Re: Keith Rosenthal  
10 Creemer Road,  
Section 108.02, Block 2, Lot 60

We are in receipt of the memorandum from David Sessions, KSCJ to the Town of North Castle Conservation Board, for the Rosenthal project. Please find attached a copy of the Revised Plan Set in addition to a comment-by-comment response to each of the review items in your comment letters.

**KSCJ Memorandum dated March 15, 2024:**

**E-1 SILT FENCE DETAIL**  
NOT TO SCALE

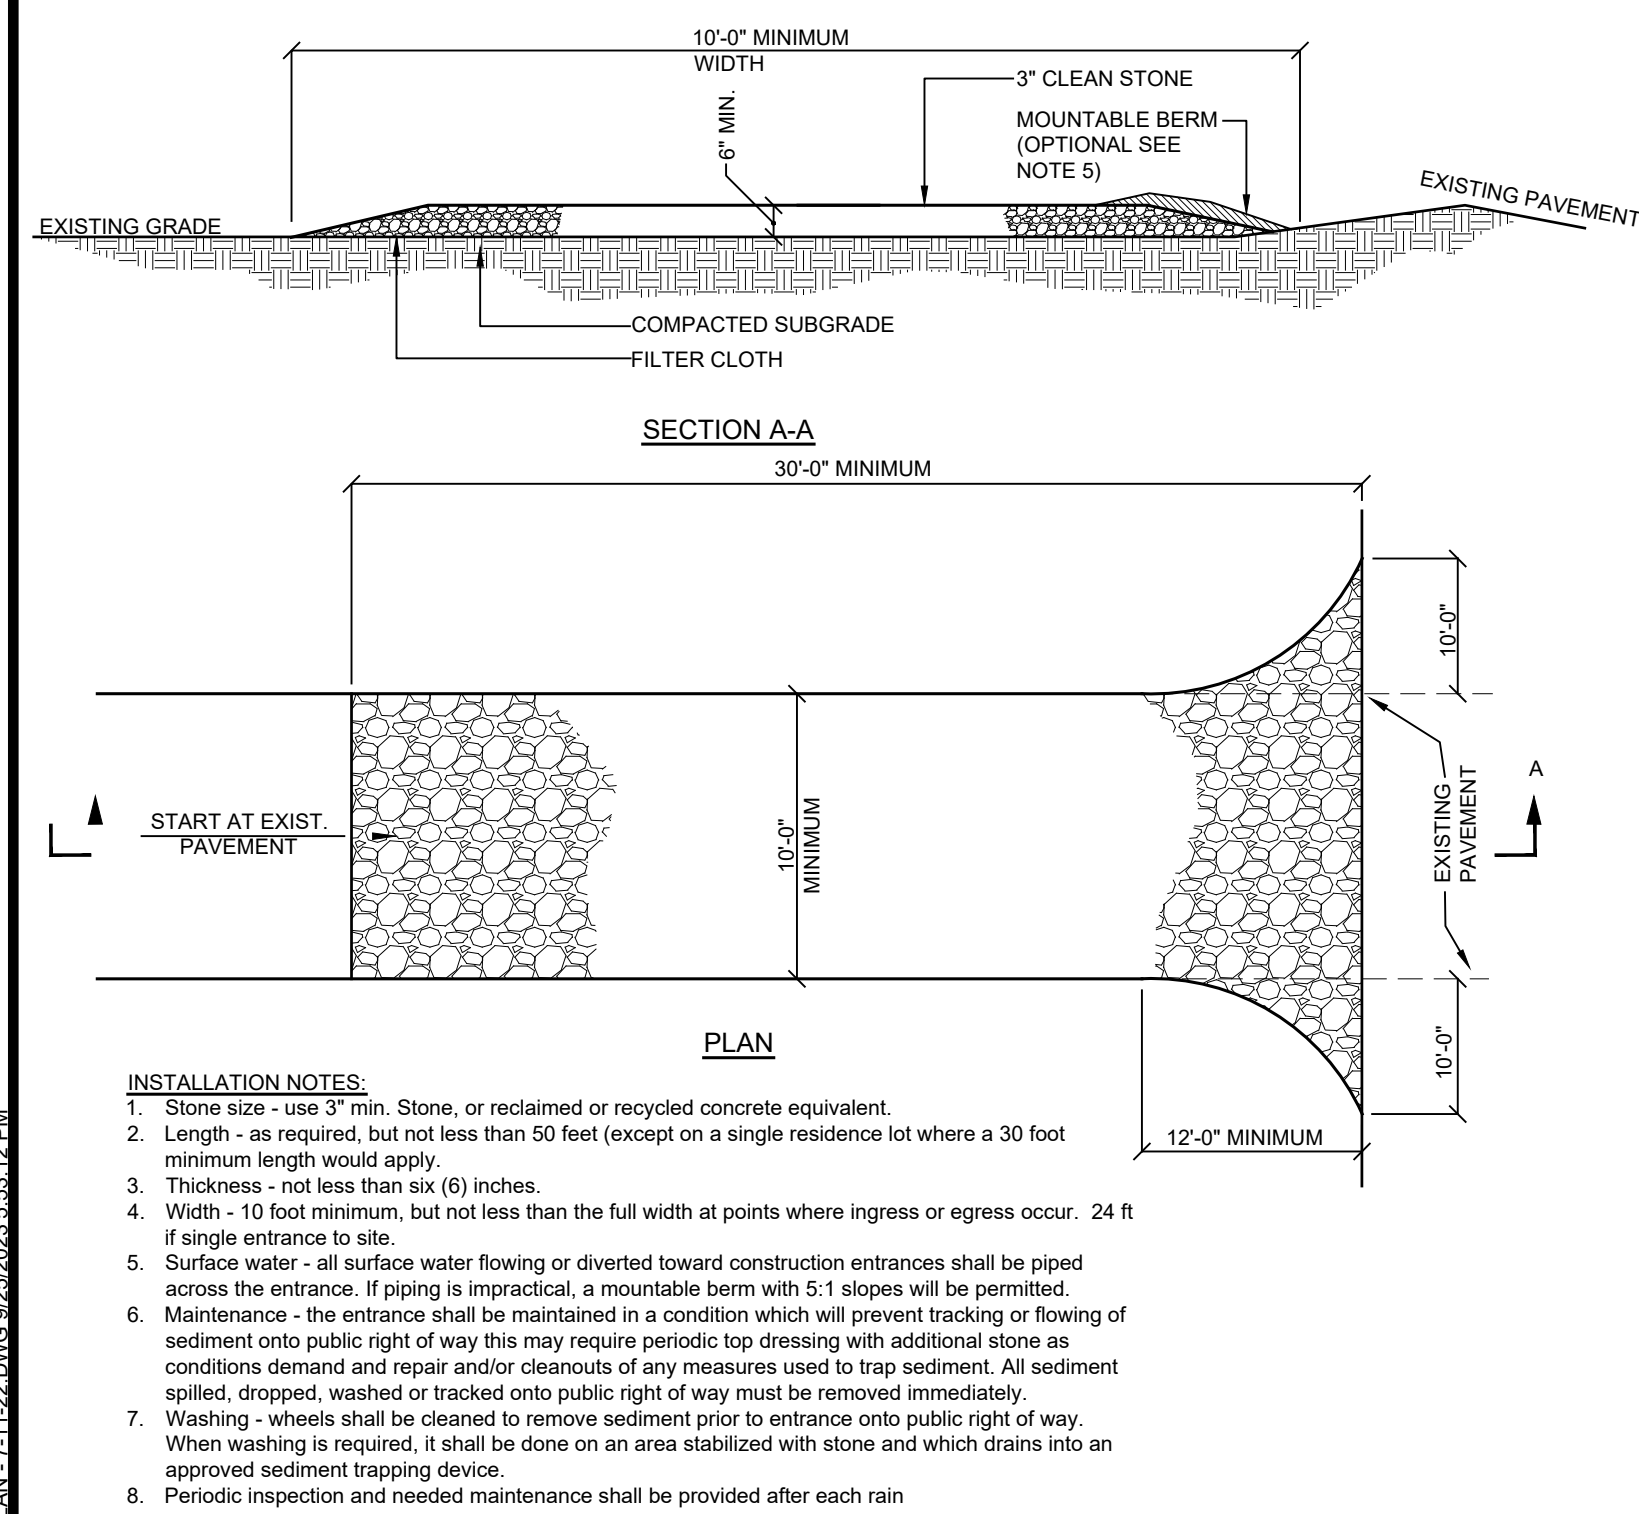
- a. *The applicant has previously prepared an erosion and sediment control plan for the project. The plan should include construction fencing along the disturbance limits in the vicinity of the proposed spa addition and the proposed rain garden, both located adjacent to or within the wetland buffer. Please re-submit the erosion and sediment control plan with this information provided.*

**Response: Previously a combination of construction and silt fence were shown. We are now showing them as separate.**

**SW-3 GRASS LEVEL-LIP SPREADER DETAIL**  
NOT TO SCALE

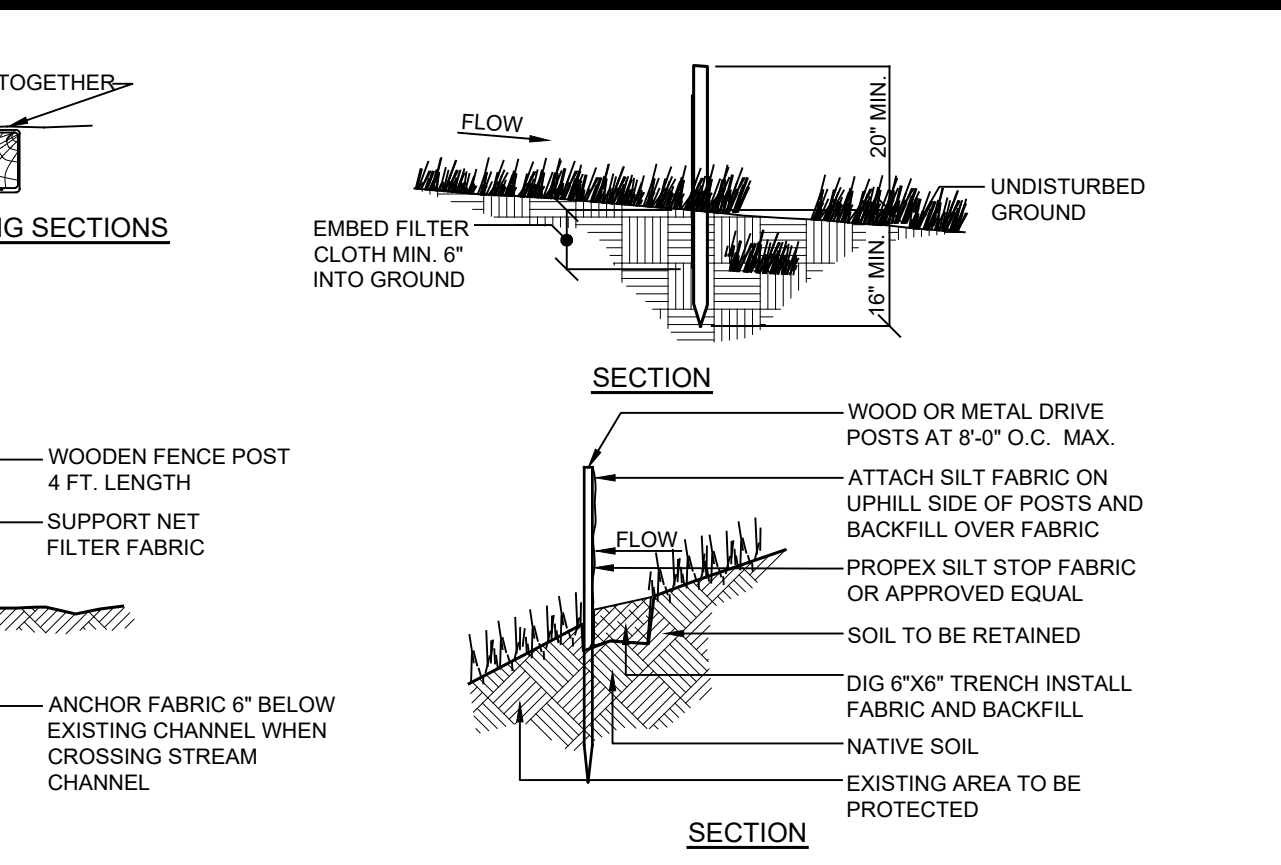
3. *The applicant will discharge from the rain garden to the adjacent freshwater wetlands, immediately downgradient of the rain garden. As previously noted in the memorandum to the North Castle Planning Board, dated October 5, 2023, the applicant should show a diffuser, level spreader, etc., required to dissipate energy and disperse flow at the discharge point. The means chosen to dissipate energy and disperse flow shall be shown on the plan and a typical detail shall also be provided on the plan.*

**Response: A vegetated level spreader has been added following the stone dissipater outlet from the rain garden outlet. A detail of both are provided on the detail sheet.**

**E-5 STONE OUTLET SEDIMENT TRAP DETAIL**  
NOT TO SCALE

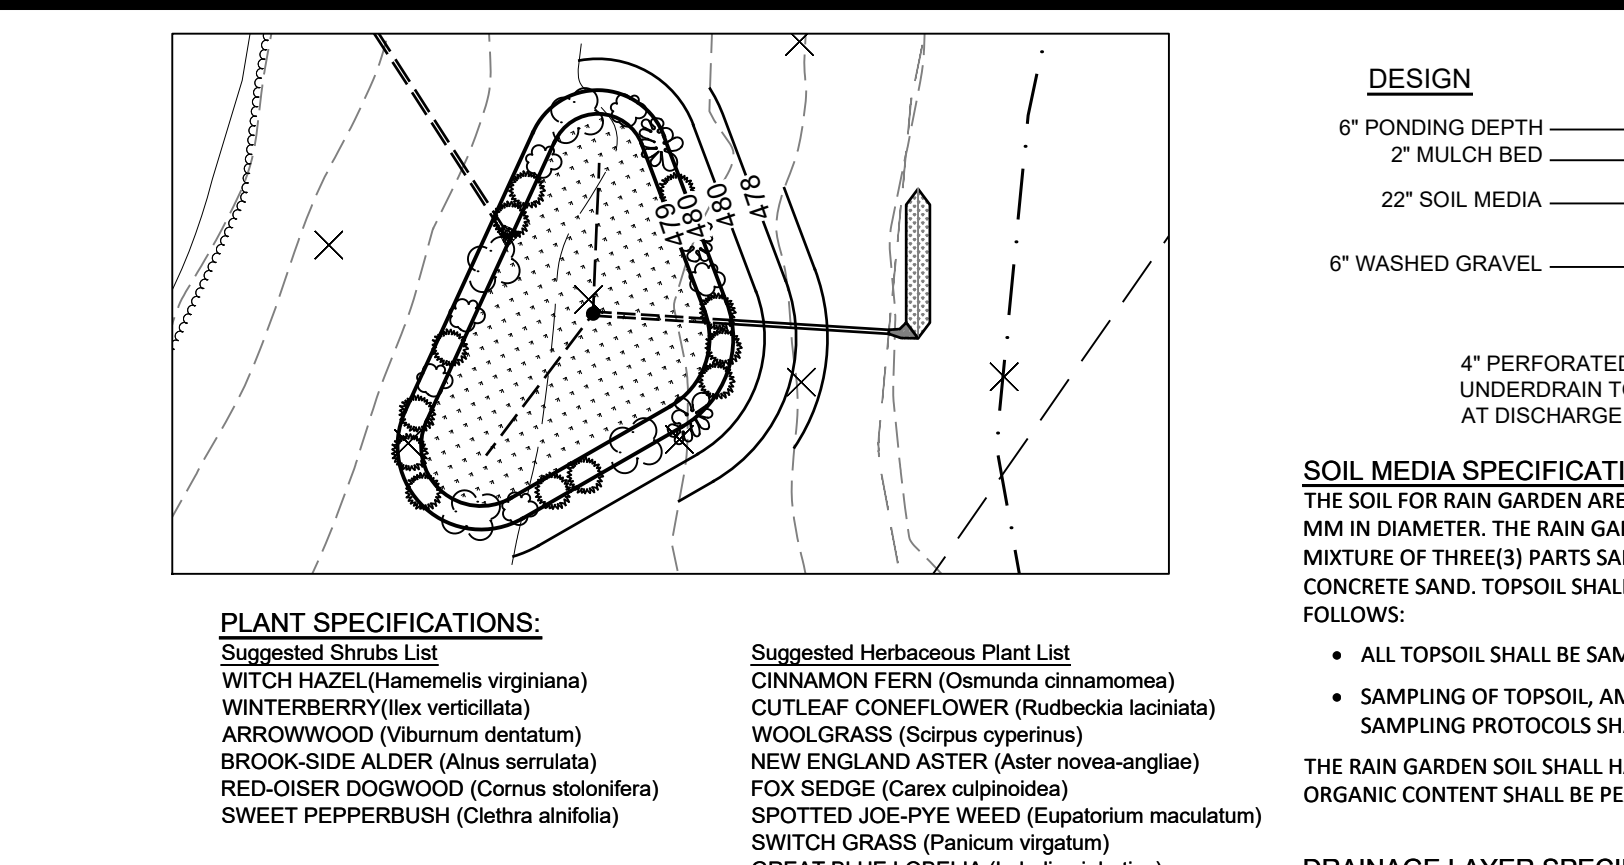
- c. *The most significant disturbance occurring on-site will be in the vicinity of the proposed building additions and motor court. This area will also be used for*

*construction staging. There is minimal protection to control erosion and protect downstream wetlands from siltation. The applicant shall examine a more specific stabilization plan for this area and provide a time limit for the proposed duration of exposed soils. When soil is exposed within this area, a temporary sediment pond shall be available to control runoff and discharge. The applicant shall include a temporary sediment pond on the plan and a typical detail shall also be provided.*

**Response: Please see note 6 in the General Erosion Control Notes addressing stabilization and time limitations. A temporary sediment basin has been added between the cottage and the spa where the natural flow of runoff occurs. A detail has also been provided.**

**E-6 EROSION BLANKET AND ANCHOR DETAIL**  
NOT TO SCALE

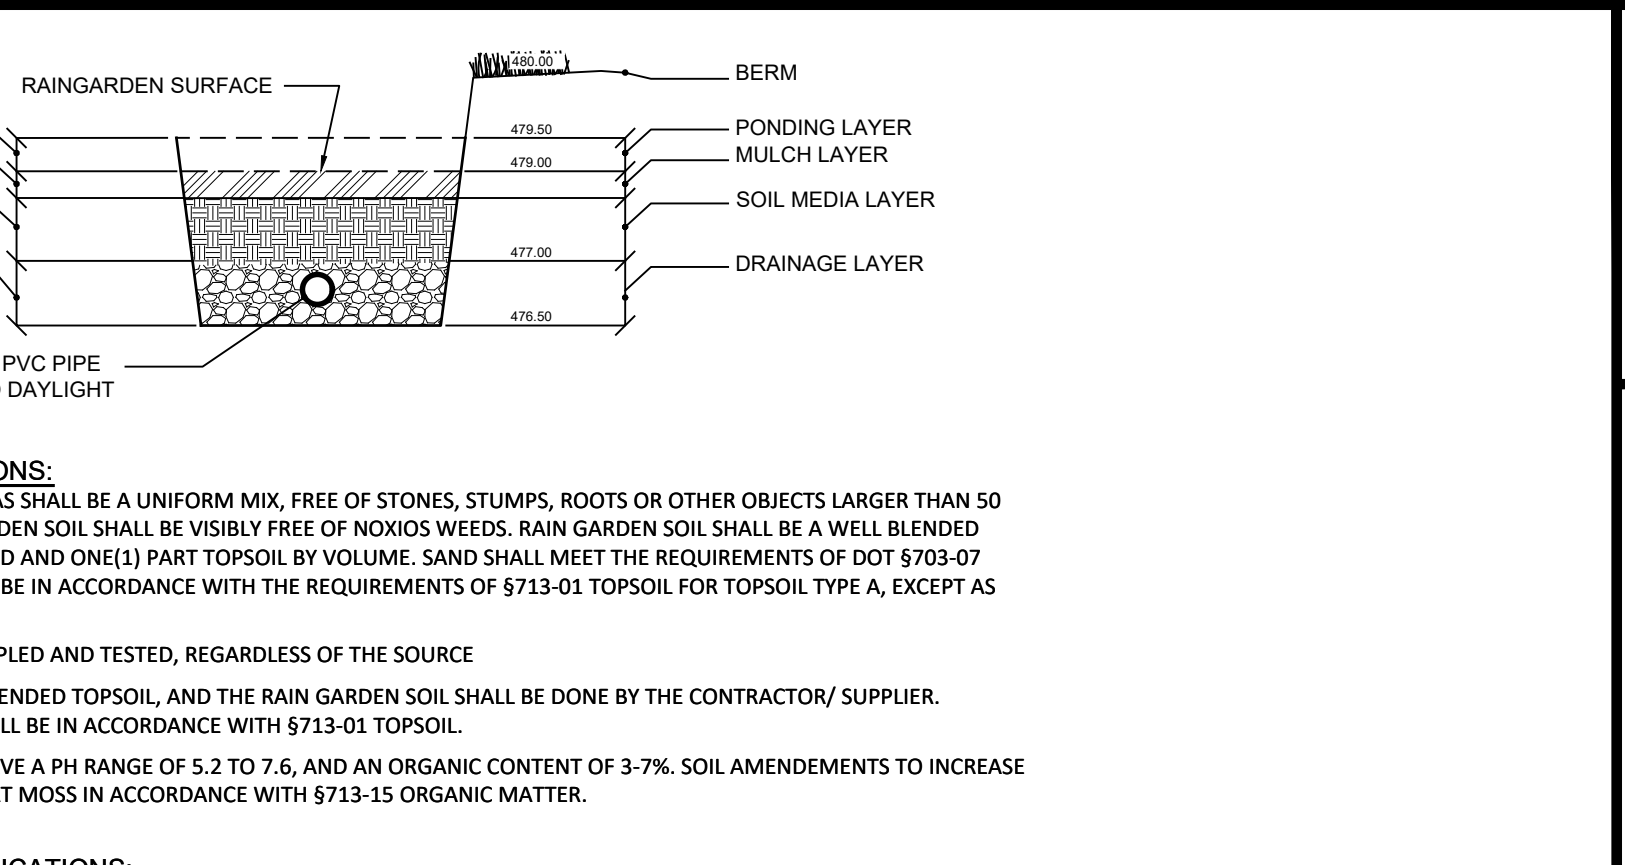
- b. *Areas adjacent to the spa and the rain garden shall only be disturbed during the growing season when restoration of the disturbances can be immediately revegetated. Disturbances to both areas should have a time limit while no vegetation is present, please provide a time limit on plans as such. The applicant shall also detail the means of stabilization for the rain garden embankment, please provide additional details as such.*

**Response: Please see note 6 under the General Erosion Control Notes. Erosion blankets have been added to stabilize the rain garden embankment as well as slopes adjacent to the addition and spa. A detail has been provided.**

WETLAND ENHANCEMENT/RESTORATION PLAN

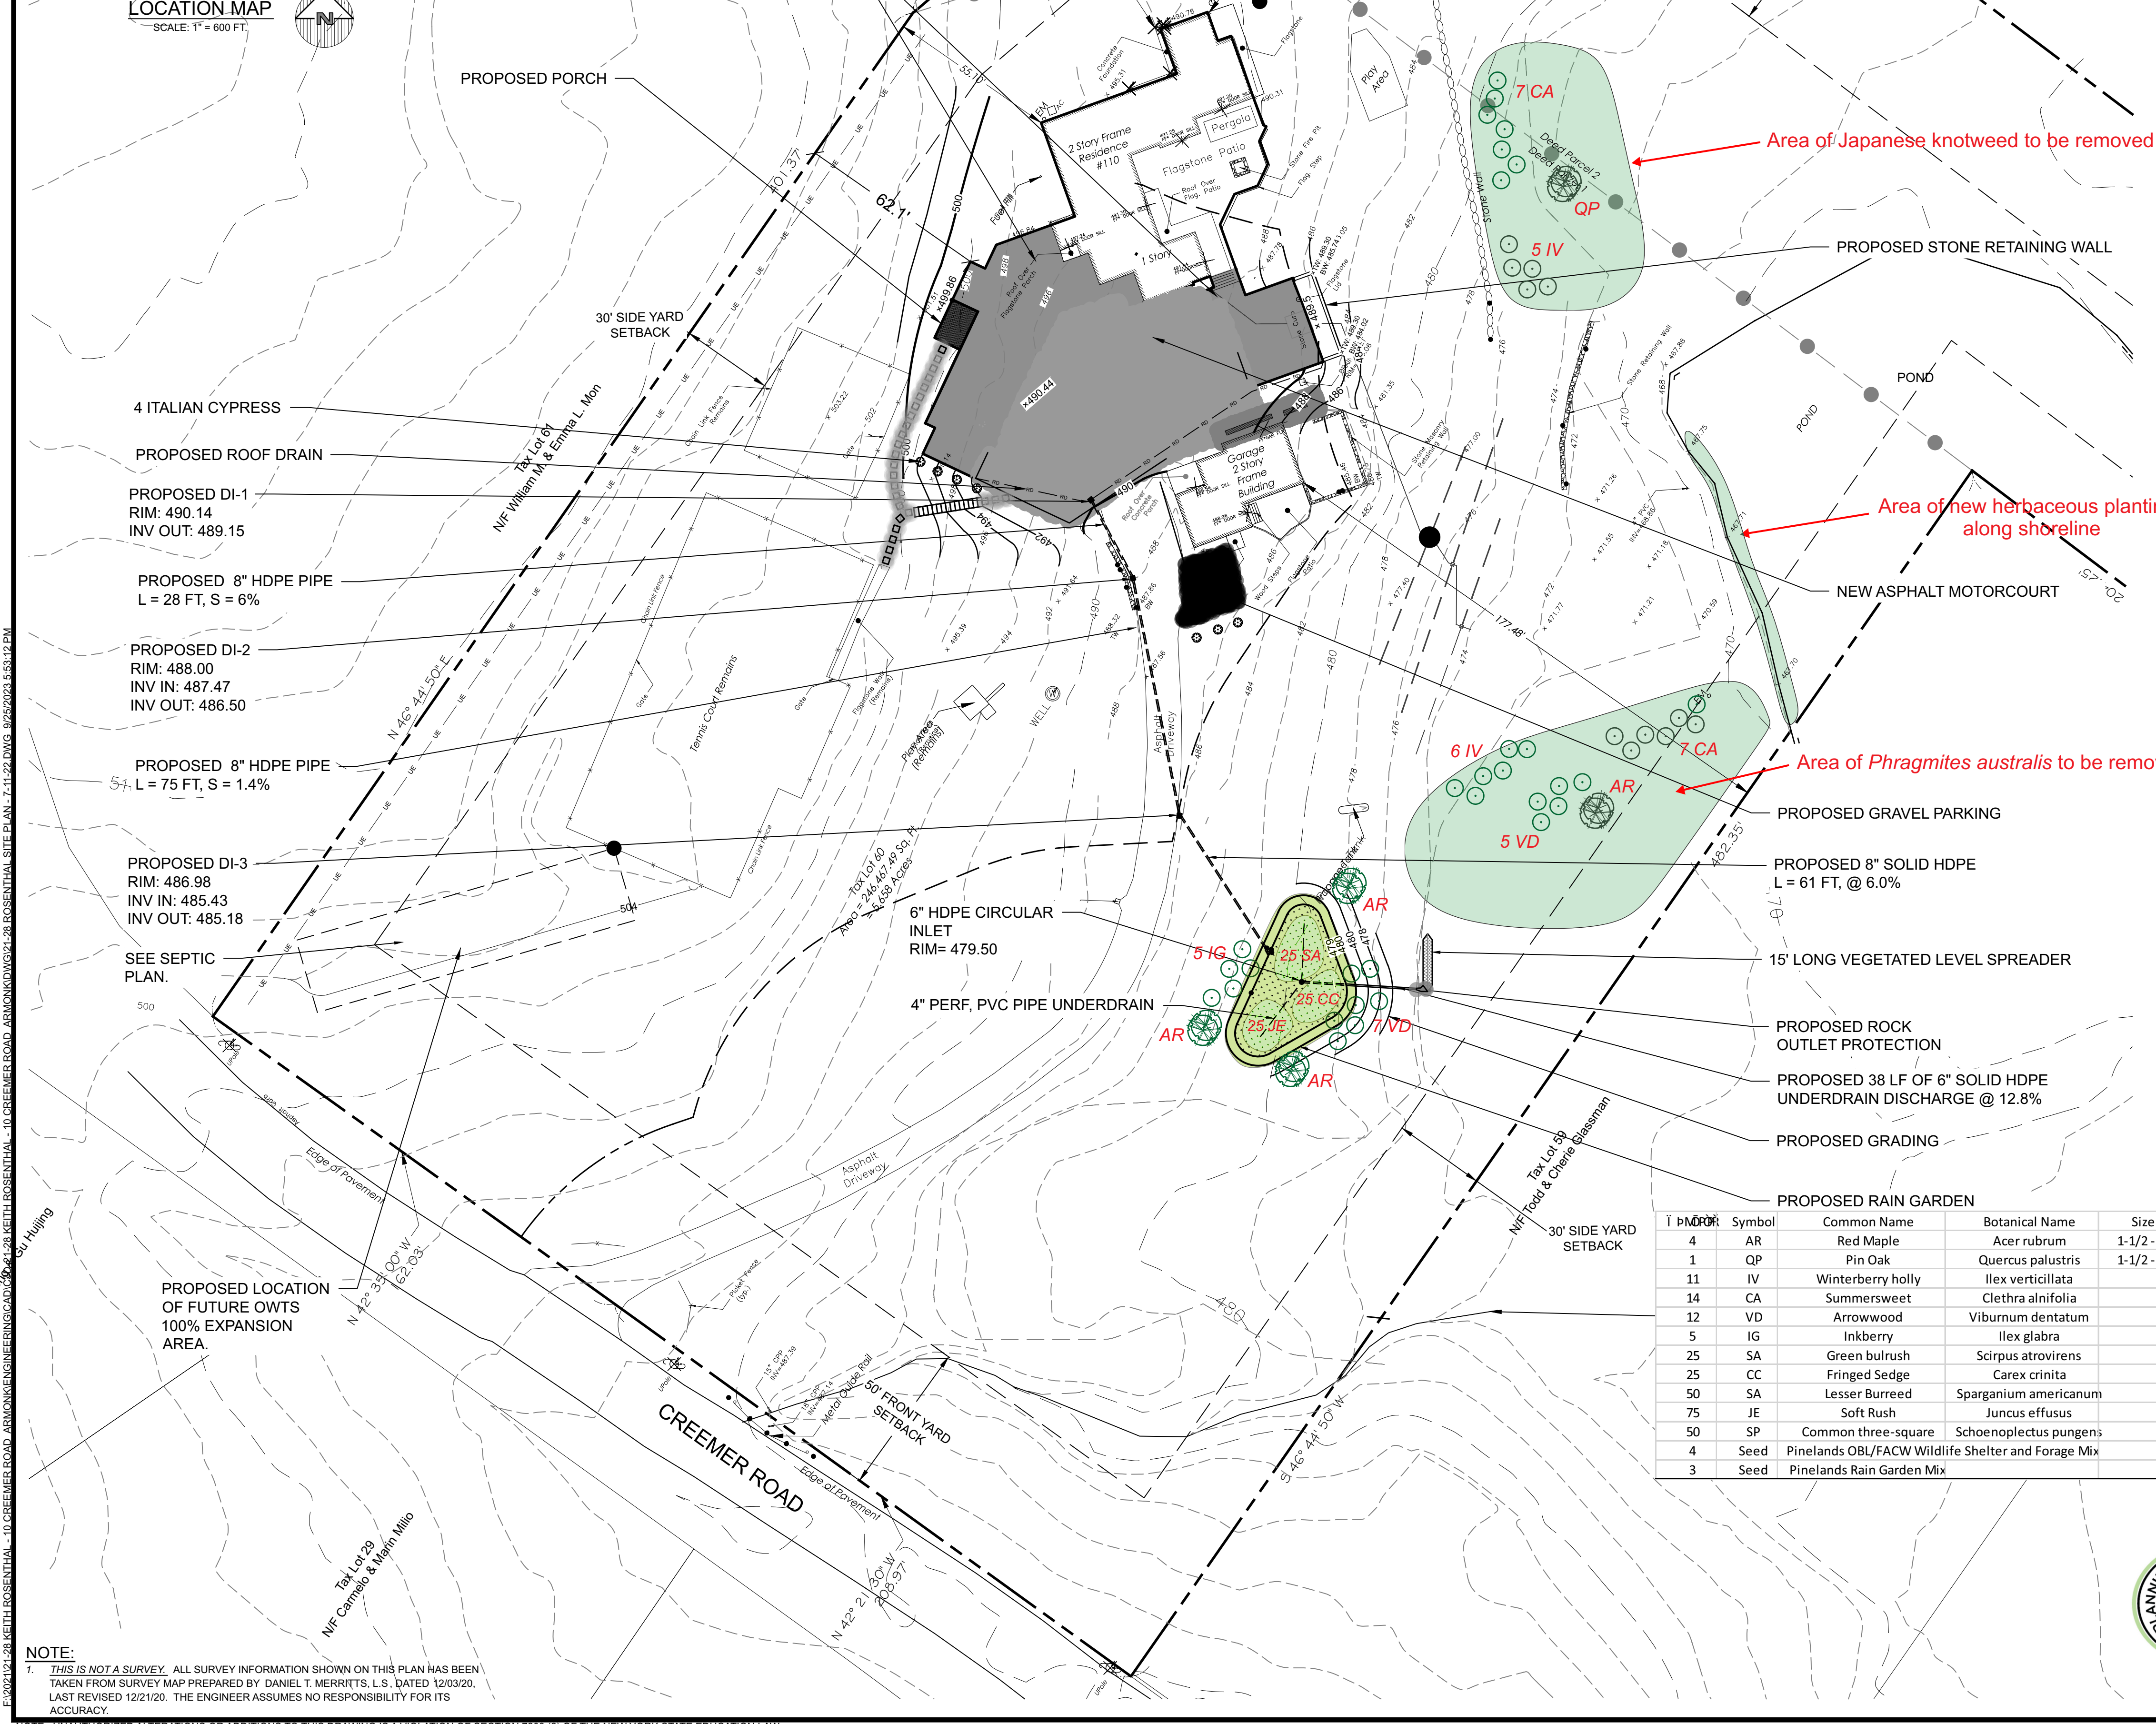
1. *To ensure plantings associated with any required wetland mitigation plan will thrive, the proposed, "Invasive Species Monitoring and Control Program" indicated on the submitted plan entitled "Wetland Enhancement/Restoration Plan" (Sheet 1 of 1) shall continue for a duration of five (5) years instead of the proposed three (3) years, post-construction. Proposed language shall be revised.*

2. *The planting schedule and planting plan shall be further coordinated:*
  - a. *Please indicate on the submitted plan entitled "Wetland Enhancement/Restoration Plan" (Sheet 1 of 1) locations of proposed seed mix and if the rain garden will include trees, shrubs, and herbaceous plant material.*

**Response: The referenced plan has been updated to show a five year duration for maintenance and monitoring.**

**Response: As shown on the revised plan, the rain garden will include shrubs and herbaceous plantings. Three trees around the perimeter of the rain garden were shown on the previous plan and remain. The plan also shows a planted fringe along the pond edge, which will filter and slow runoff from the maintained lawn area and provide additional habitat so that any additional "no-mow" area is not necessary.**
